Gulfstream Aerospace Corporation.

for an exemption from § 25.813(e) of Title
14, Code of Federal Regulations

Regulatory Docket No. FAA-2010-0446

GRANT OF EXEMPTION

Figure 1 - Acoustic and Forward Vestibule Door Arrangement

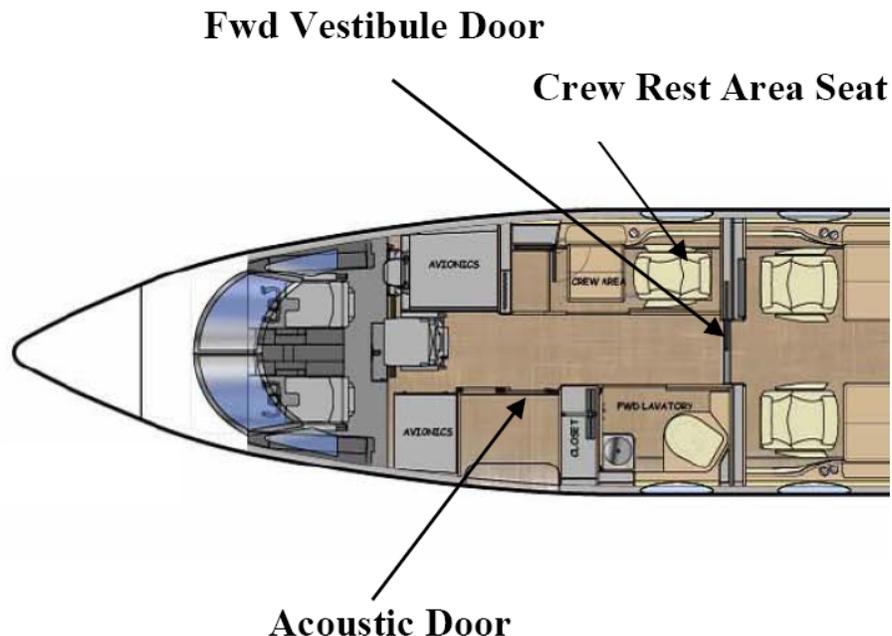
The GVI design incorporates two doors between the passenger seating areas and the main entry door. See Figure 1, Acoustic and Forward Vestibule Door Arrangement. One door will be an acoustic door provided between the forward vestibule and the main entry door. Its purpose is to maintain an acceptable acoustic level in the passenger cabin and pilot compartment and will be standard equipment. The second door will be a forward vestibule door and is offered on certain interior configurations. An example of one such configuration is depicted below. Its purpose is to provide:

The applicant states that the GVI aircraft complies with § 25.807(g) for required number of emergency exits through the over wing exits and the MED is an emergency exit in excess of the minimum required on the left hand side of the aircraft. The FAA disagrees with Gulfstream's position because the MED is one of the compensating factors used to support issuance of the ELOS to allow installation of the non standard size over wing exits in lieu of a true Type III exit on the right hand side of the aircraft. However, the FAA acknowledges that the aircraft has five exits in lieu of the required minimum of two, as described above. The four over wing exits provide a compensating factor to allow issuance of an ELOS. Each pair of over wing exits must be shown to be equivalent to a single Type III exit. The substantiation of the over wing exits must account for any obstructions of the exits as a result of other ELOS activity related to the exits.

In past practice the FAA has also required that interior doors have an Emergency Passage Feature (EPF) to allow passage of the occupants and/or rescue personnel in the event the door(s) become jammed. This EPF may be through frangibility and/or a removable emergency panel or equivalent. The EPF must be easily broken/removed by the occupant when the door(s) is jammed and a placard must be installed on each side of the door(s) providing instruction on the operation of the EPF. A demonstration is required to show that a 5th percentile female can break through or remove the EPF from both sides of the door(s). The 5th percentile female test subject should be subjected to a typical preflight briefing and then may only use the information on the placard for determining how to operate the EPF. The demonstration must be conducted in accordance with an FAA approved test plan on a conformed installation. Additionally, the applicant must show that a 95th percentile male subject can exit through the EPF opening.

1. The doors must be designed to automatically open (stow) when the landing gear is down or the flaps are not fully retracted and must remain open until the landing gear and flaps are both fully retracted.
2. The doors will only be installed forward of the passenger seating area and between passenger seats and the main entry door (MED).
3. Emergency exit locator and marking signs and emergency lighting in accordance with §§ 25.811 and 25.812 will be provided.

4. The doors must be designed so that they can only be closed (deployed) when the gear and flaps are fully retracted (airborne configuration), or for ground maintenance activity.

5. The doors must be designed so that for any failure of the closing/latching mechanism, the doors will default to the open (stowed) position.
6. Gulfstream must substantiate that the probability of failure to egress through the MED, including the probability of failure of both interior doors, to be less than 10^{-5} per flight hour. This hazard criticality is based on § 25.783(b)(2).

7. The doors must have a hold-open feature that will be shown to react to all emergency landing loads specified under § 25.561(b).
8. The doors must be placarded to be open and latched for taxi, take-off and landing (TT&L).

9. An Amber CAS message, that will alert the pilots if an interior door is not in the properly open (stowed) position for TT&L, must be installed.
10. With the doors in the open (stowed) position, the critical forward emergency landing loads must not cause either door to deploy and block access to the main entry door.

11. The doors must have an Emergency Passage Feature (EPF) to allow passage of the occupants and/or rescue personnel if the door(s) become jammed. This EPF may be through frangibility and/or a removable emergency panel or equivalent. The EPF must be easily broken or removed by the occupant when the door(s) is jammed and a placard must be installed on each side of the door(s) providing instruction on the operation of the EPF. A demonstration is required to show that a 5th percentile female can break through or remove the EPF from both sides of the door(s). The 5th percentile female test subject should be subjected to a typical preflight briefing and then may only use the information on the placard for determining how to operate the EPF. The demonstration must be conducted in accordance with an FAA approved test plan on a conformed installation. Additionally, the applicant must show that a 95th percentile male subject can exit through the EPF opening.

Figure 2 - GVI Emergency Egress Routes

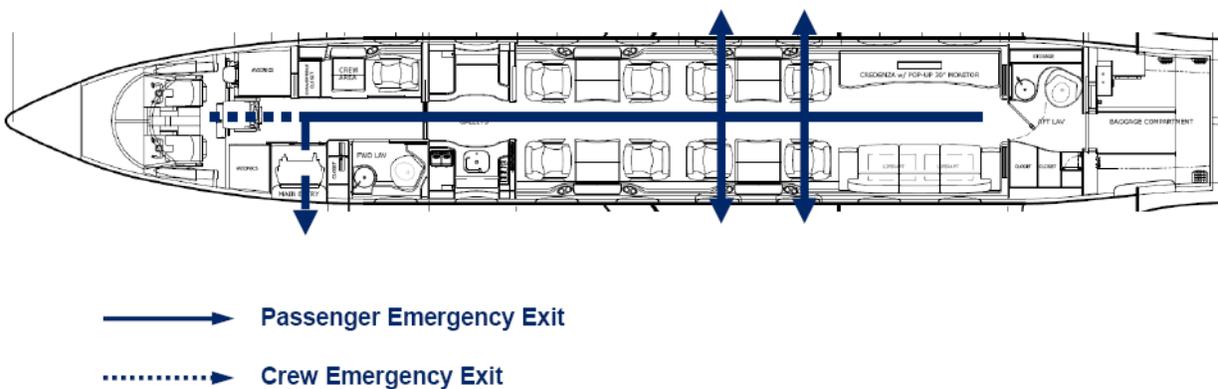
heightened passenger awareness and ease of identification will increase the likelihood of passengers utilizing the over wing exits provided in the cabin versus defaulting to the entry door. Reference Figure 2, GVI Emergency Egress Routes.

- The over wing emergency exits have been designed so that they can all be deployed at the same time to provide multiple, redundant egress paths for escape from the passenger compartment. Each of the four over wing emergency exits require single file egress and have been sized to provide substantial egress area. This reduces the problems caused by passenger panic and congestion typical in single, larger exits. Smooth, effective egress of passengers through the existing over wing exits will also increase the likelihood of passengers utilizing the over wing exits as opposed to seeking alternate escape routes further away (MED). Reference Figure 2, GVI Emergency Egress Routes.

12. Each pair of over wing exits must shown to be equivalent to a single Type III exit. This substantiation must account for any obstructions of the exits as a result of other ELOS activity related to the exits.
